REMARKS

Amendments have been made to the specification, claims 16 and 17 have been added, and claims 1, 2 and 4-15 have been amended. Reconsideration of this application, as amended, is respectfully requested.

III. Objection to the Drawings

FIG. 1

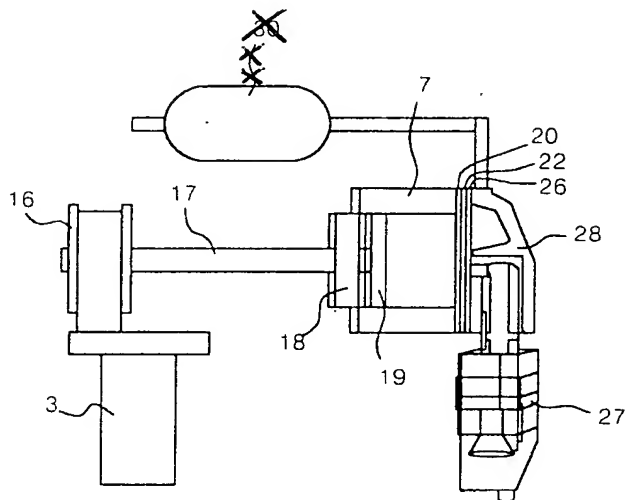
The Examiner has objected to the drawings, stating that Figs. 1 and 2A-2D should be labeled with a legend such as --PRIOR ART--.

not approved
rel
10/17/03

In order to overcome this objection, Applicants are concurrently submitting Replacement Sheets of drawings for the Examiner's approval, which include the label "Related Art". Applicants submit that the label "Related Art" meets the criteria of MPEP § 608.02(g) and is sufficient to distinguish Applicants' invention from that which is not Applicants' invention. Additional changes have been made to place the drawings in better form. Accordingly, reconsideration and withdrawal of this objection are respectfully requested.

FIG. 2A

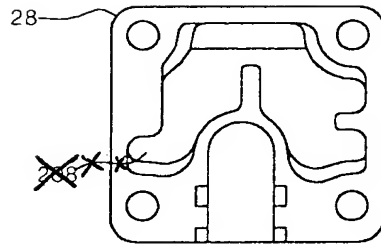
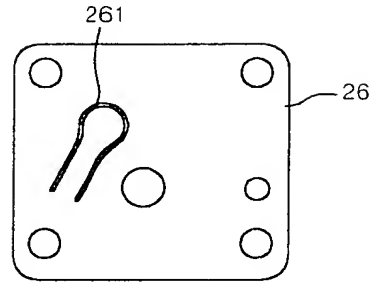
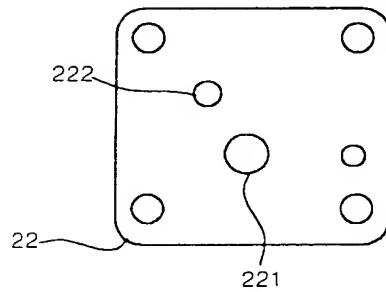
not approved
RK
10/17/03
